CALL NO. 105
CONTRACT ID NO. 171035
ADDENDUM # 1

Subject: Boone County, STPM 5138 (066)
Letting September 29, 2017

- (1) Revised - Plans - R1, R2C, R2D, R7, R25, R42A
- (2) Revised - Bid Items - Pages 173-175 of 175

Boone County US 42 AT RICE PIKE STMP 5138 (066)

COUNTY OF	ITEM NO.	SHEET NO.
BOONE	06-0412.00	RI

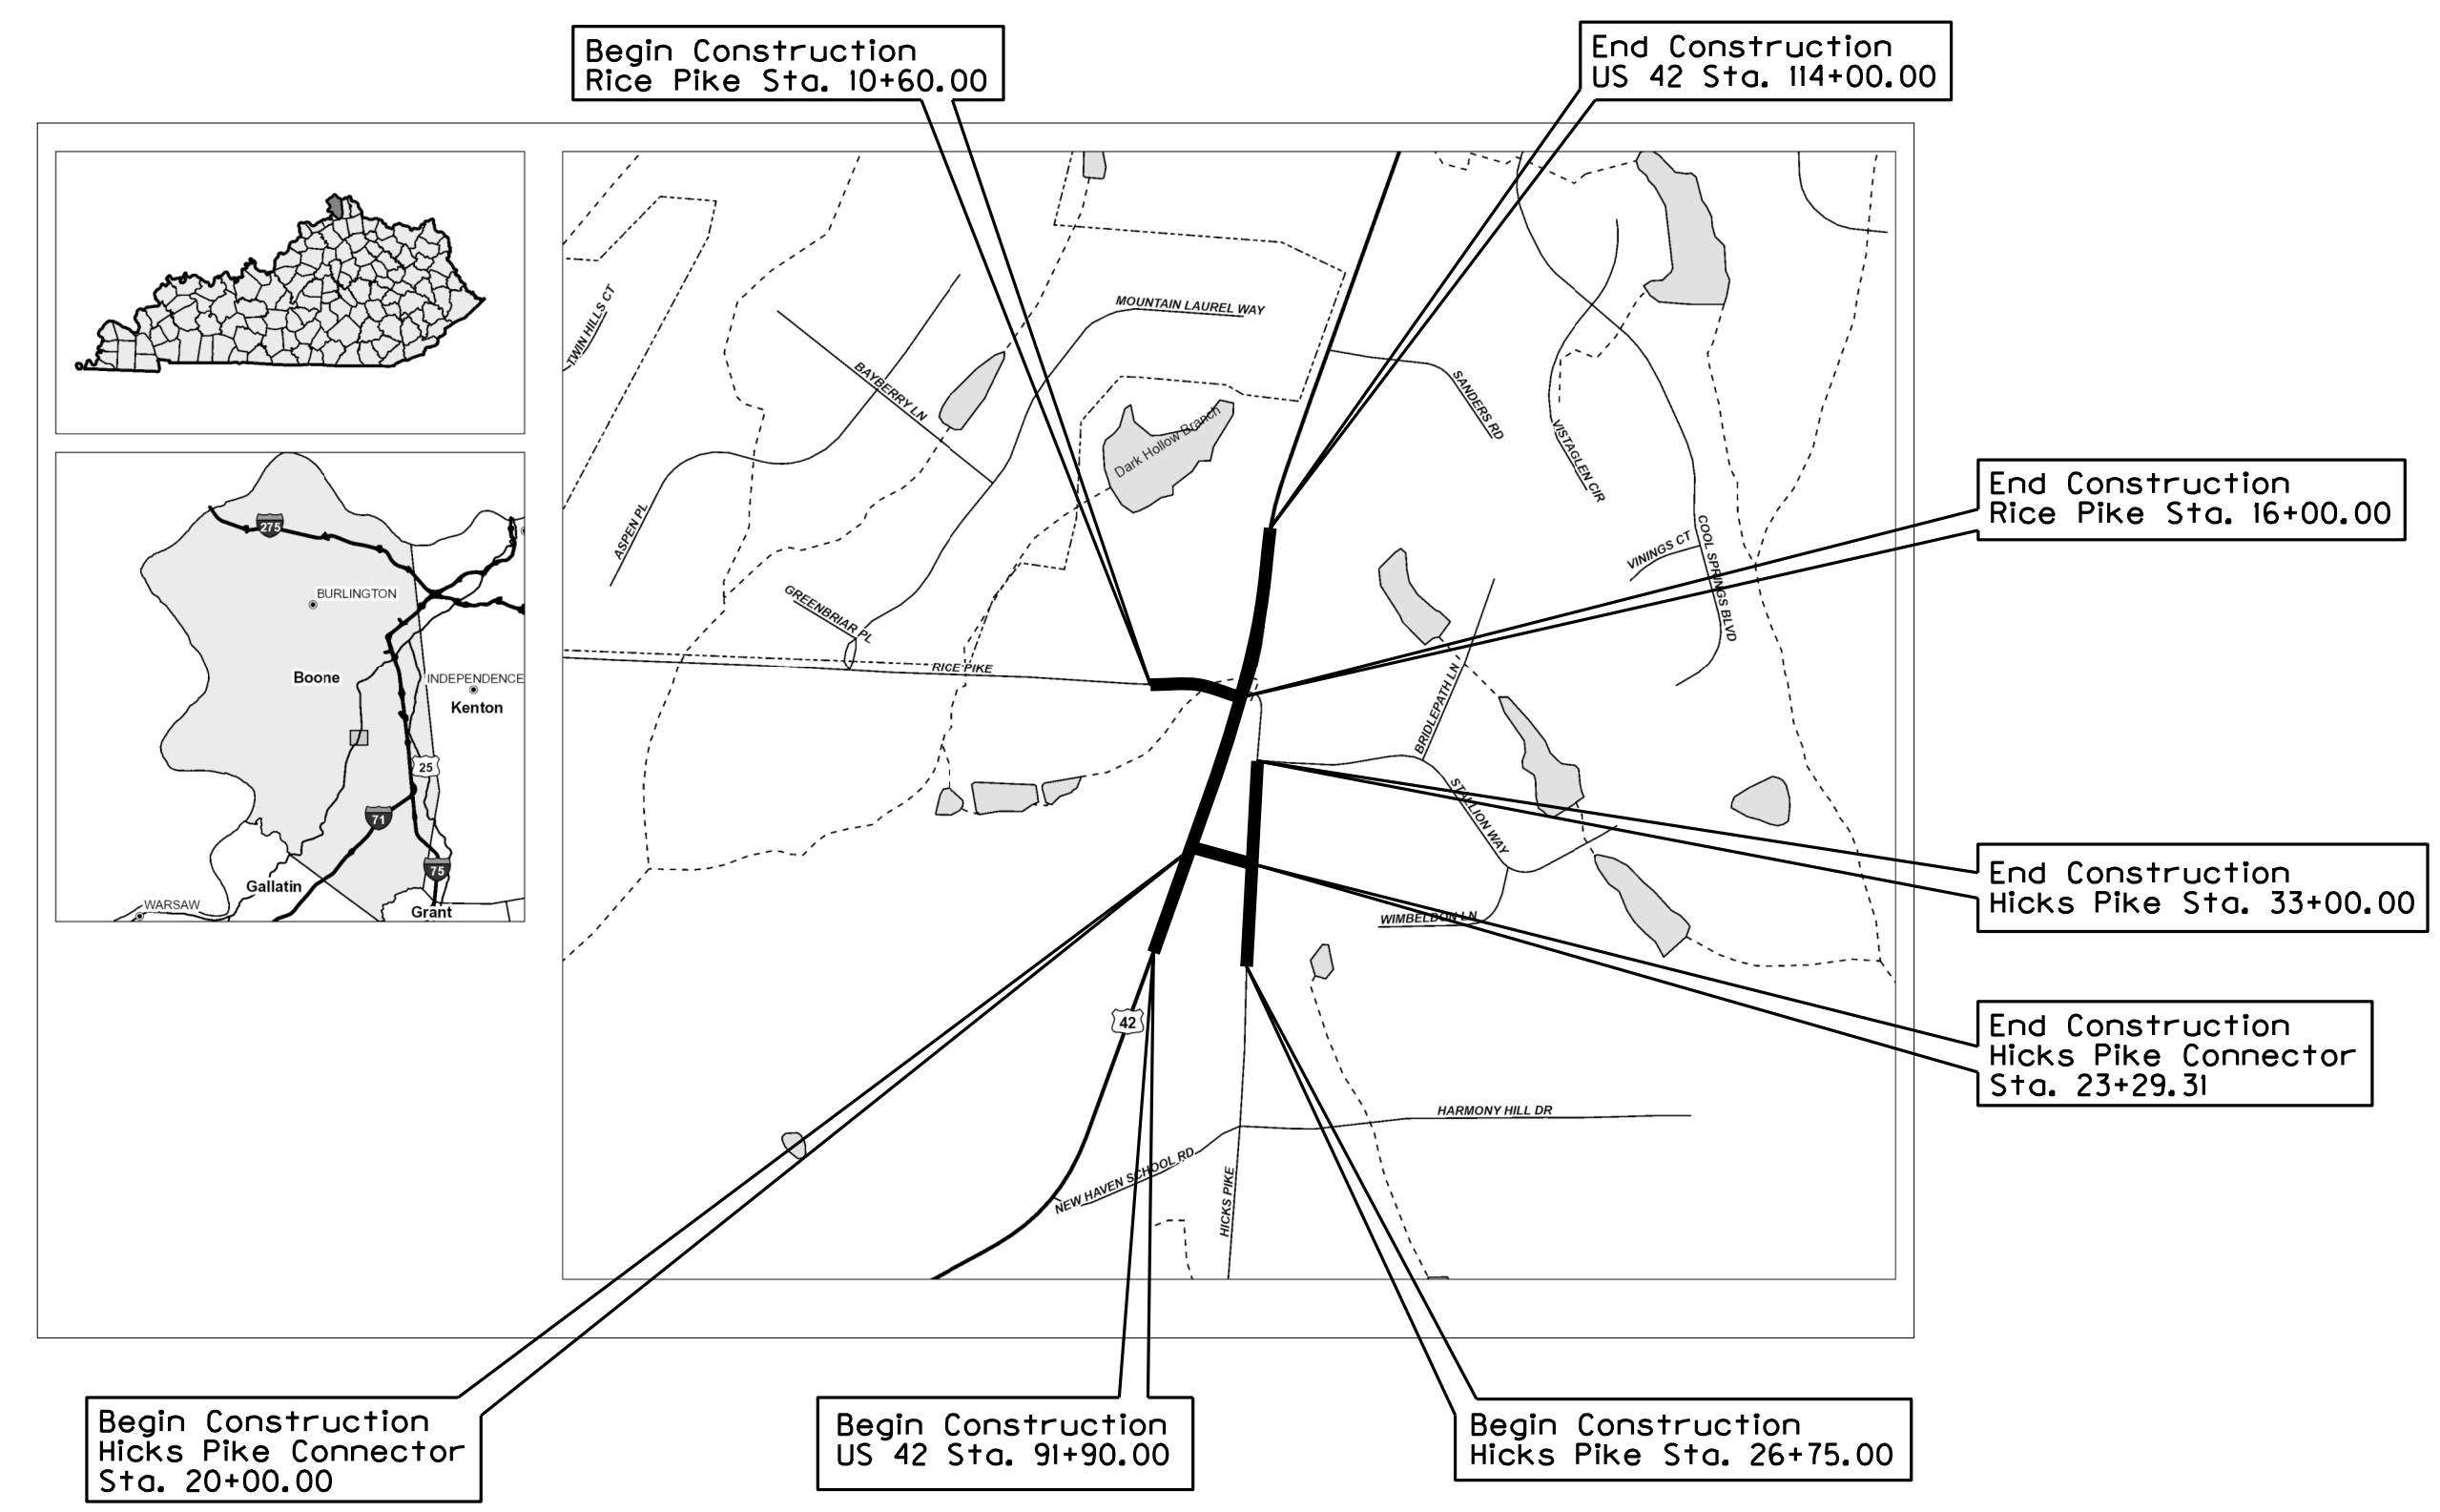
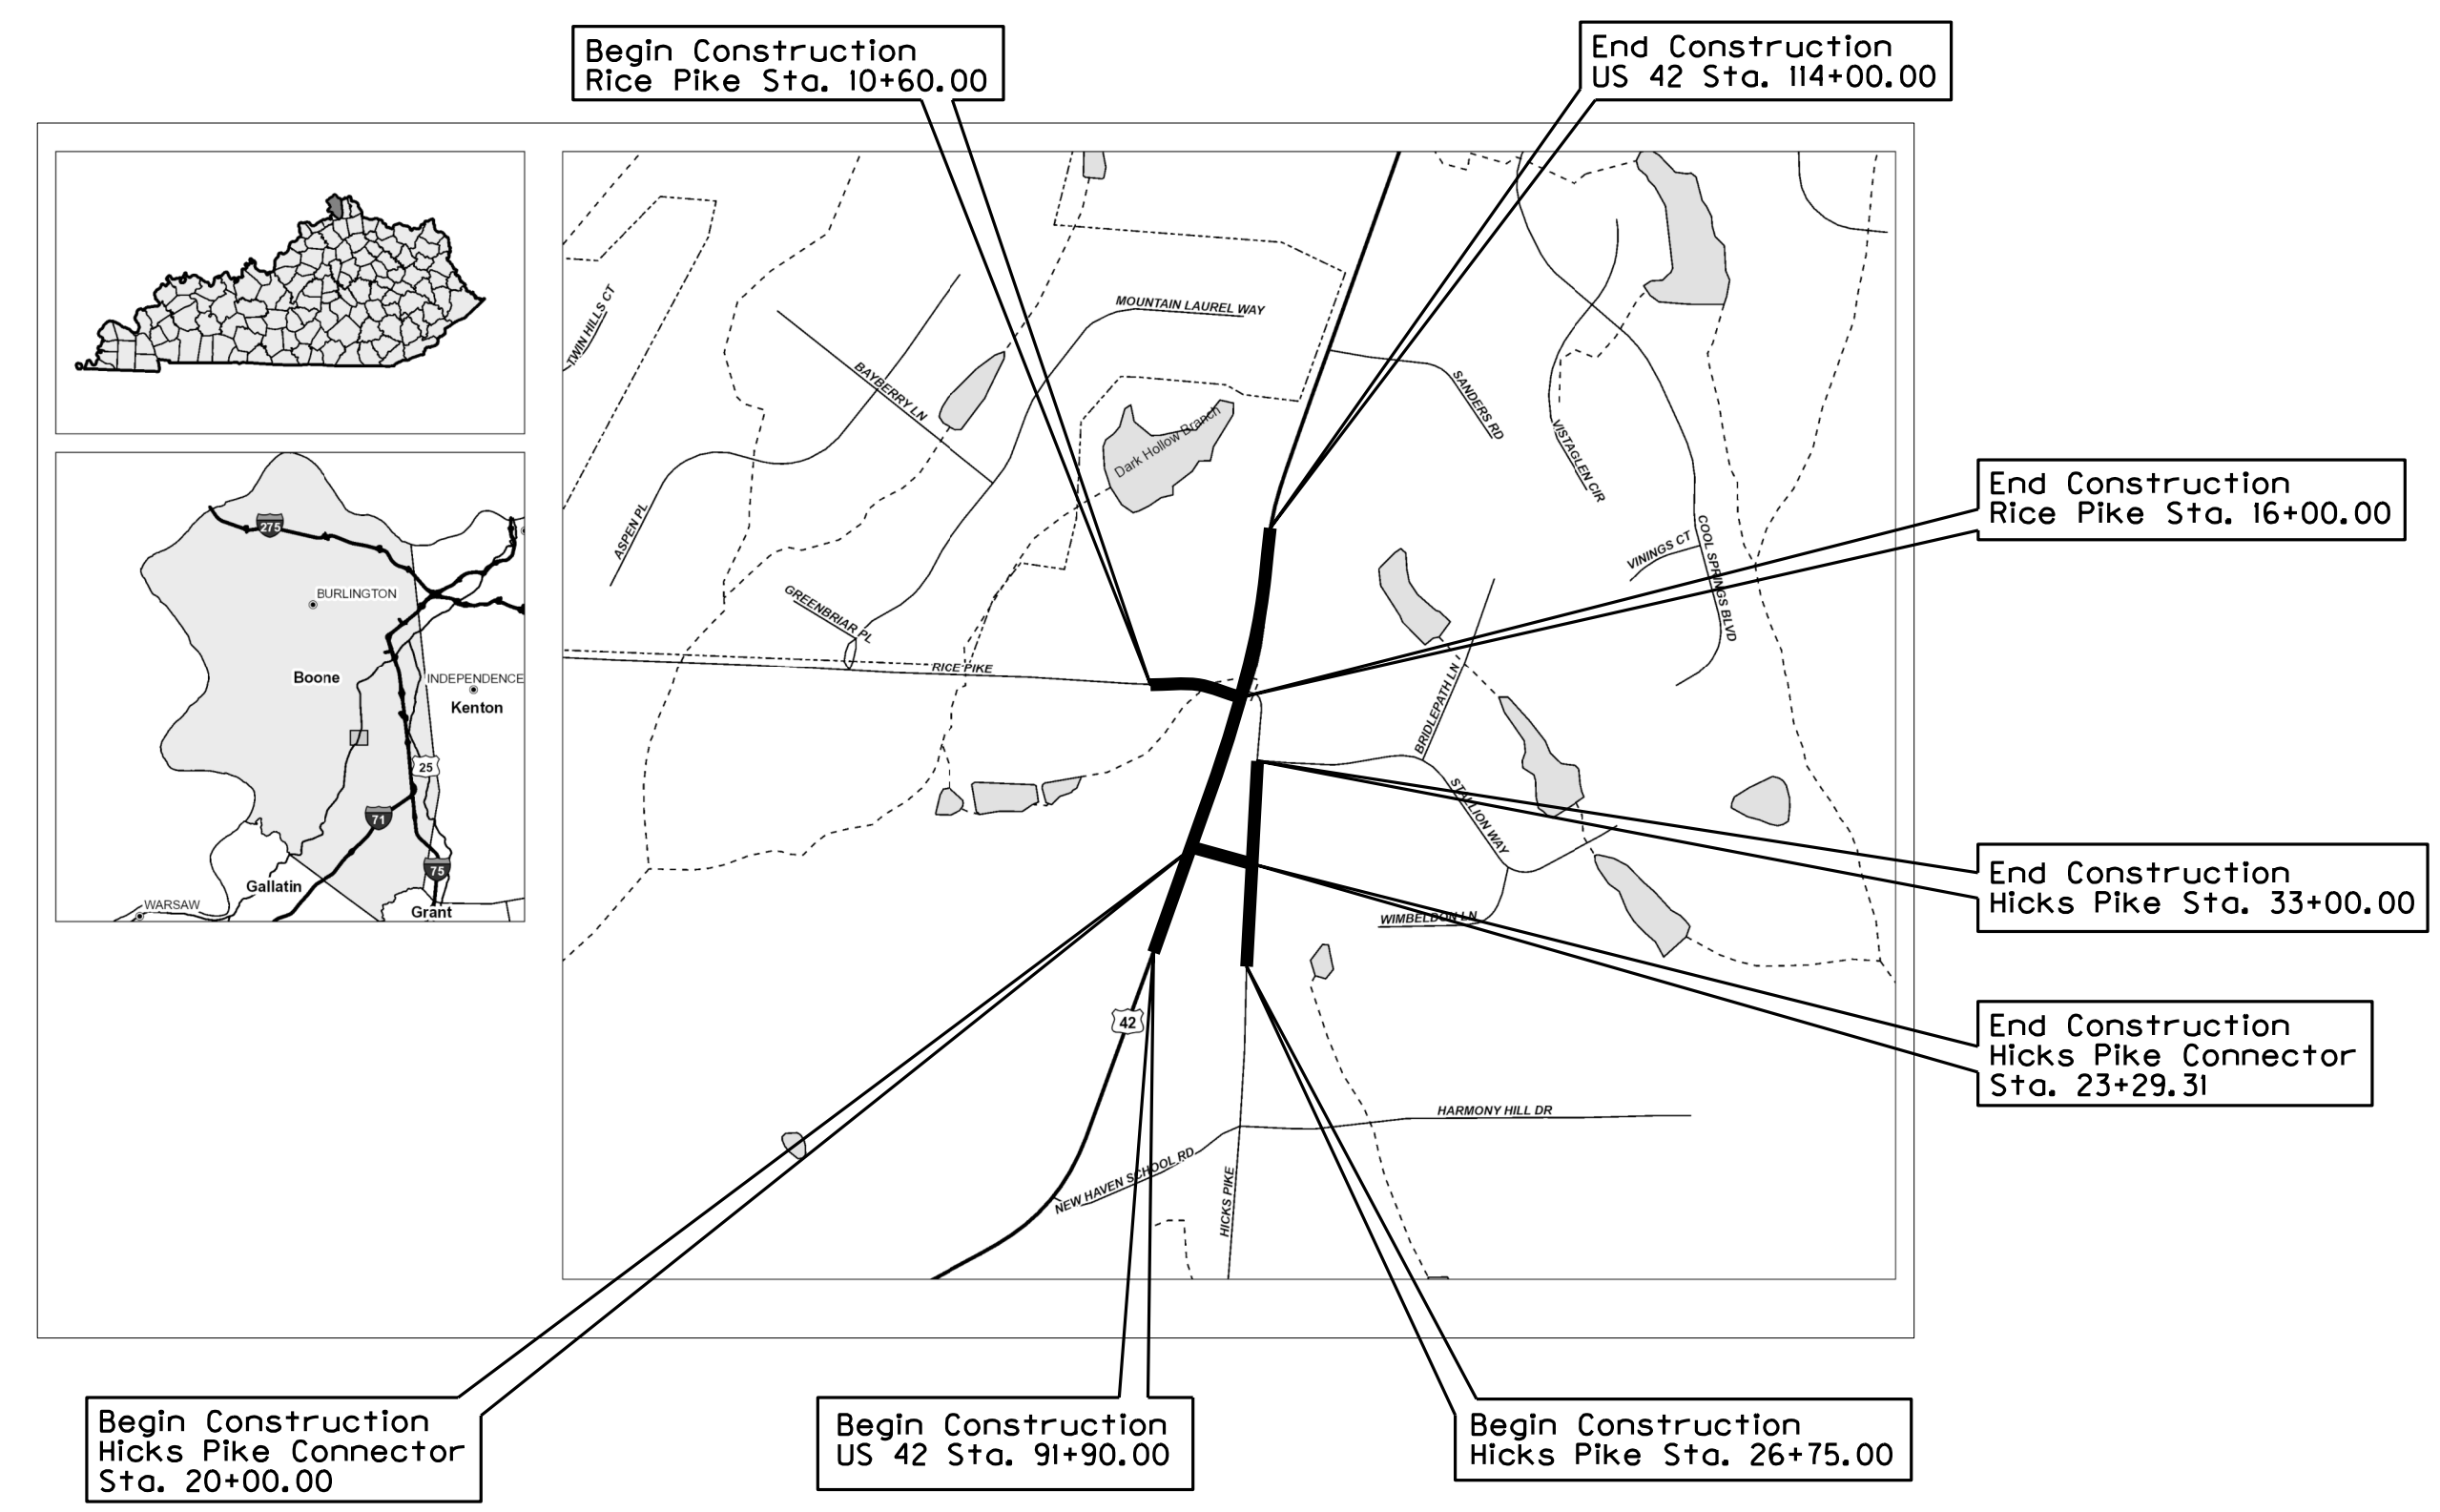
Added Sheet Number

US 42
PLAN SHEET ADDENDUM
STA. 101+00 TO STA. 107+00

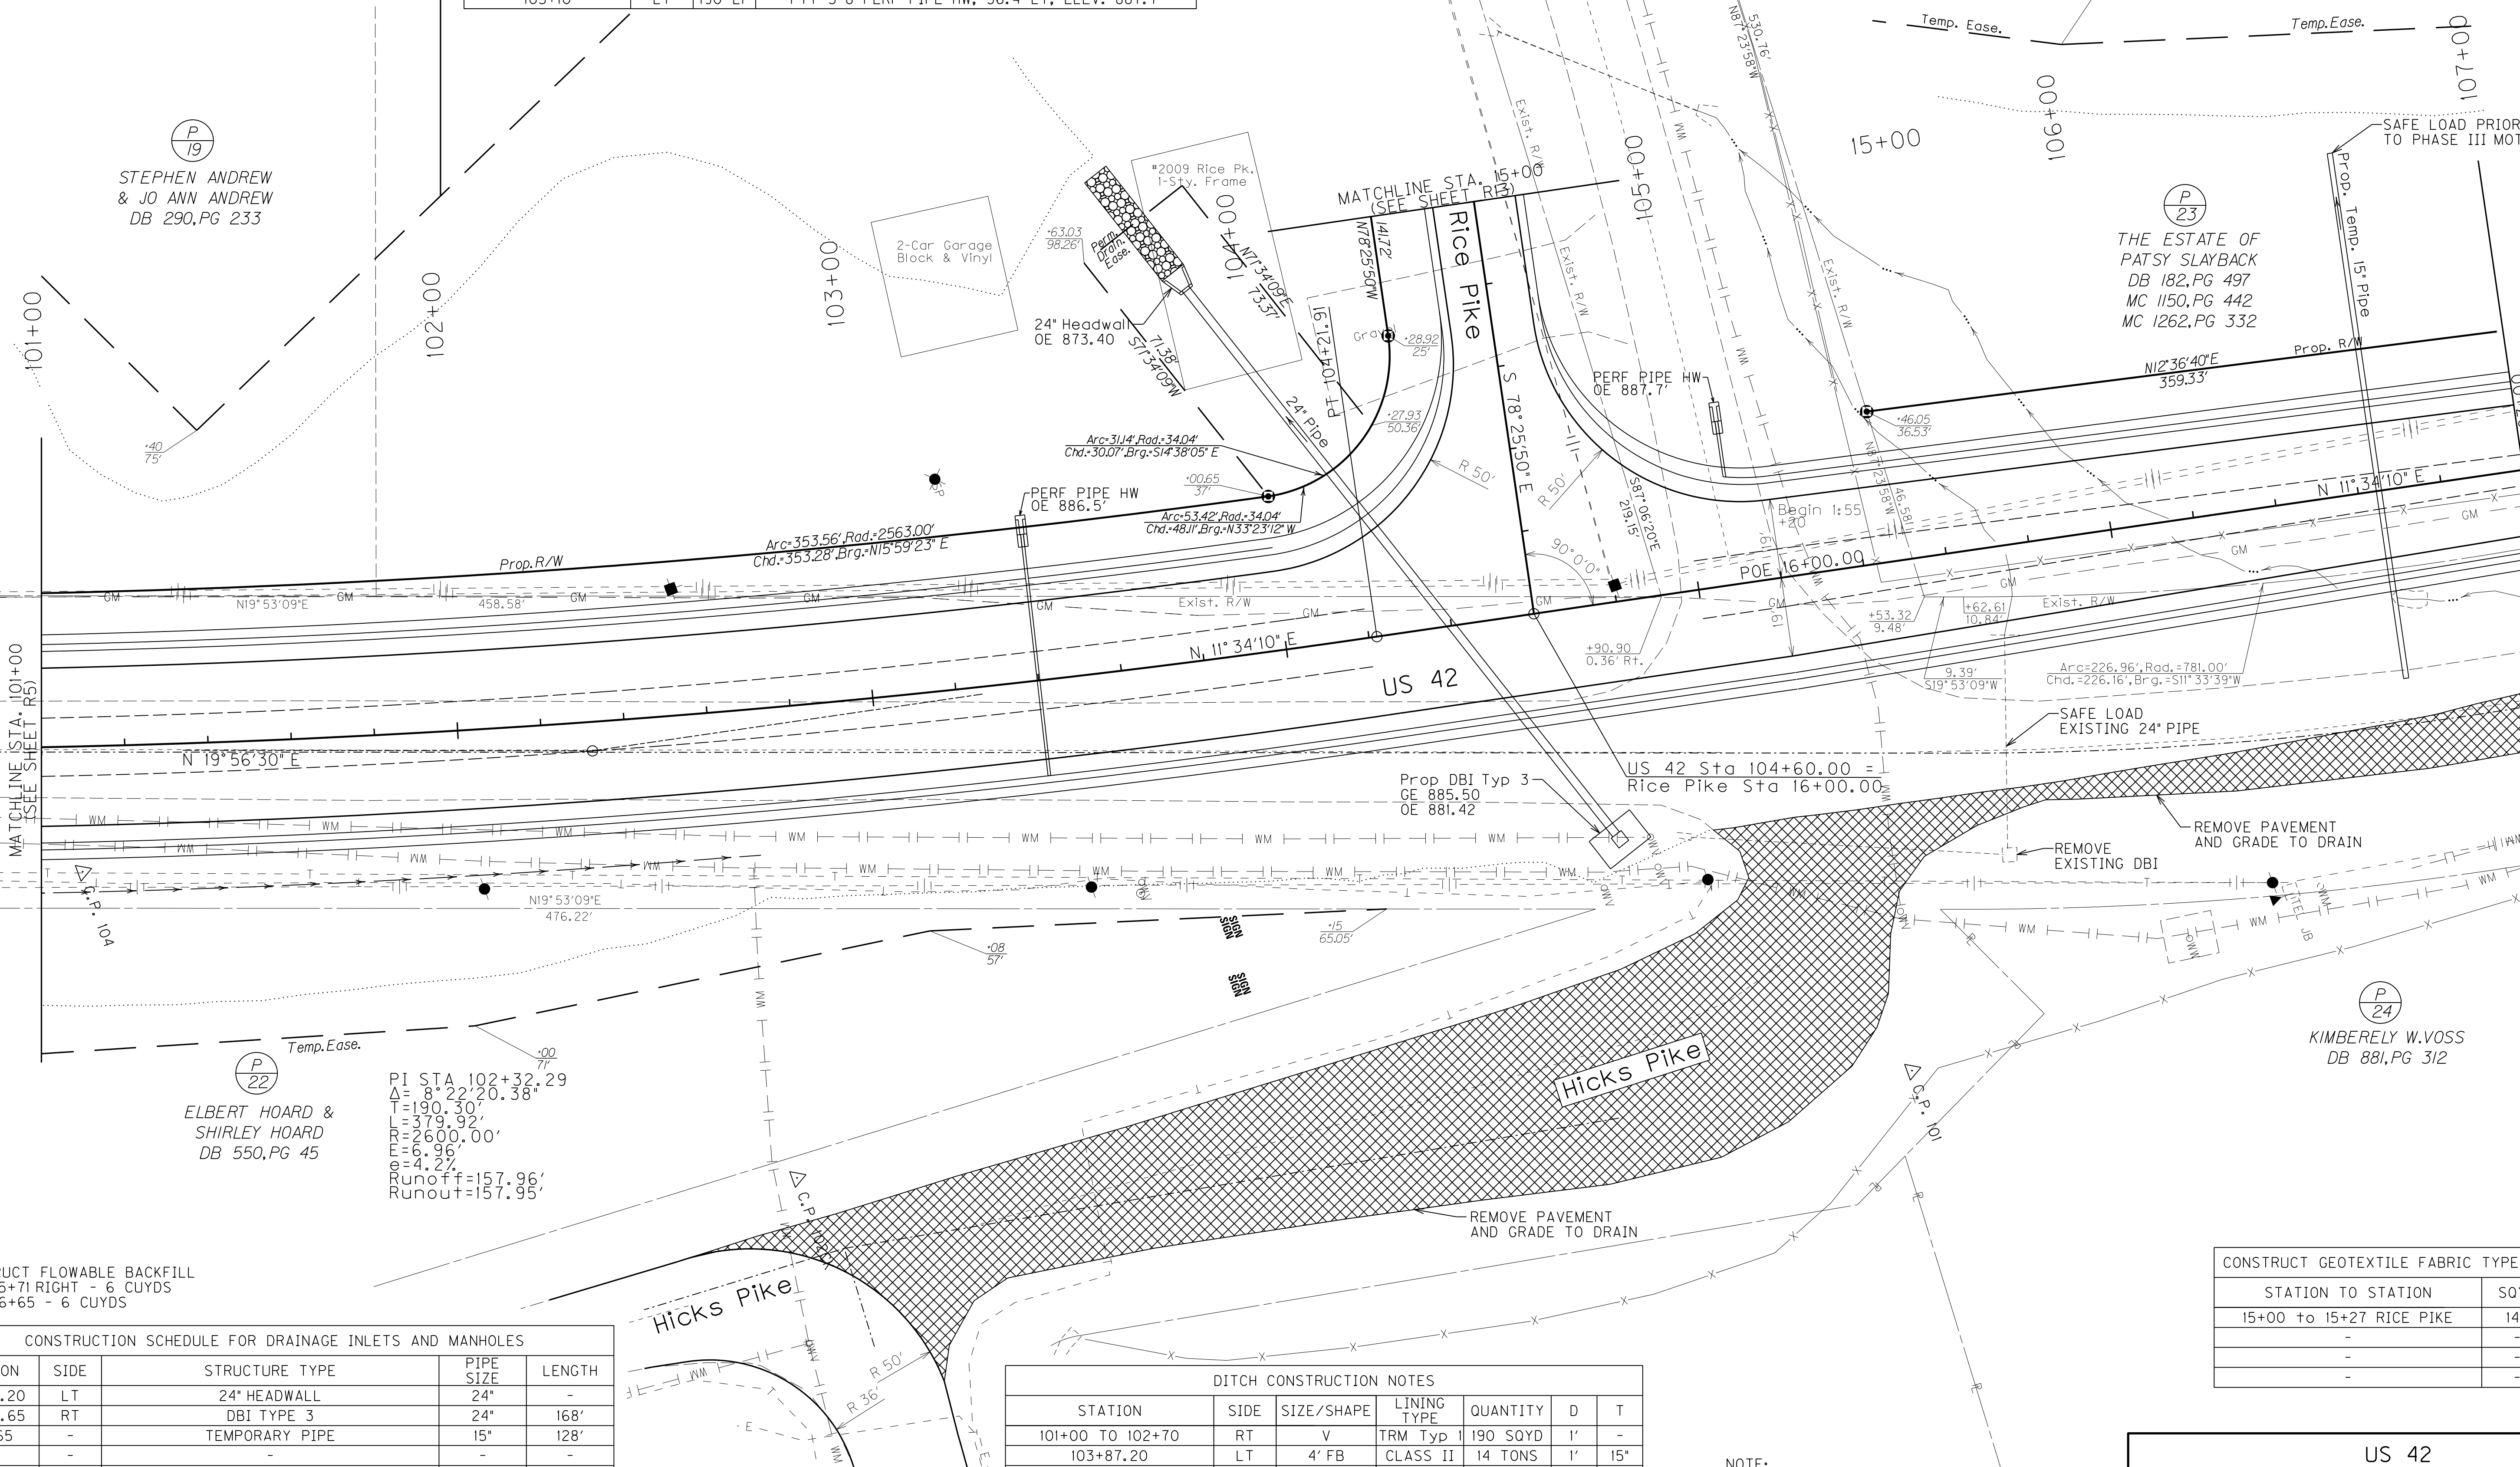
Added 15" Pipe For
Temporary Drainage
During Construction
